UNITED STATES
DEPARTMENT OF THE INTERIOR
BUREAU OF LAND MANAGEMENTRECEIVED
DEB ArtesiaFORM APPROVED
OMB NO. 1004-0137
Expires: January 31, 2018**SUNDRY NOTICES AND REPORTS ON WELLS**
*Do not use this form for proposals to drill or to re-enter an abandoned well. Use form 3160-3 (APD) for such proposals.*5. Lease Serial No.
NMNM0405444A
6. If Indian, Allottee or Tribe Name

☒ Oil Well ☐ Gas Well ☐ Other8. Well Name and No.
TODD 26J FED 21

** BLM REVISED ** BLM REVISED ** BLM REVISED ** BLM REVISED ** BLM REVISED **

PROPOSED WELLBORE

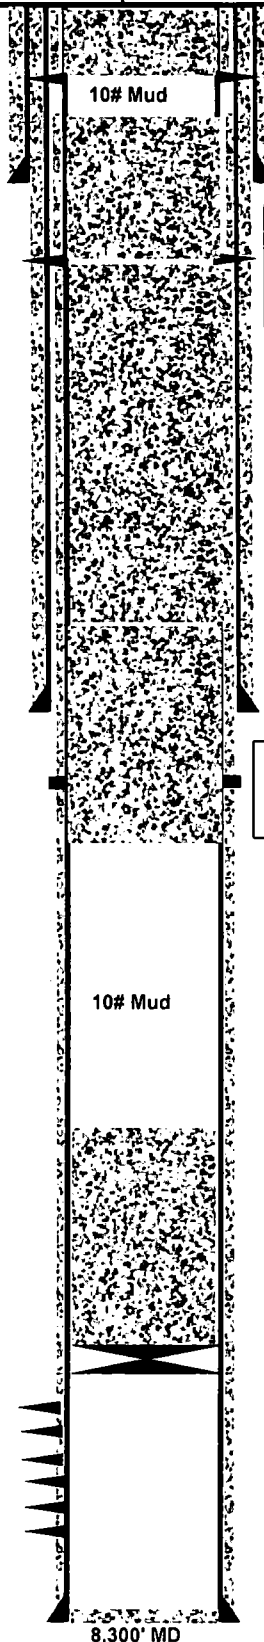
"R-III-P" Solid Plug

Run CBL from 4250 - Surf.
To Determine TOC 5 1/2"
CSG.Perf @ TOC (Per CBL) SQZ cont to
796' WOC Tag. (Salt, Shoe)

Below ground level dry hole marker required
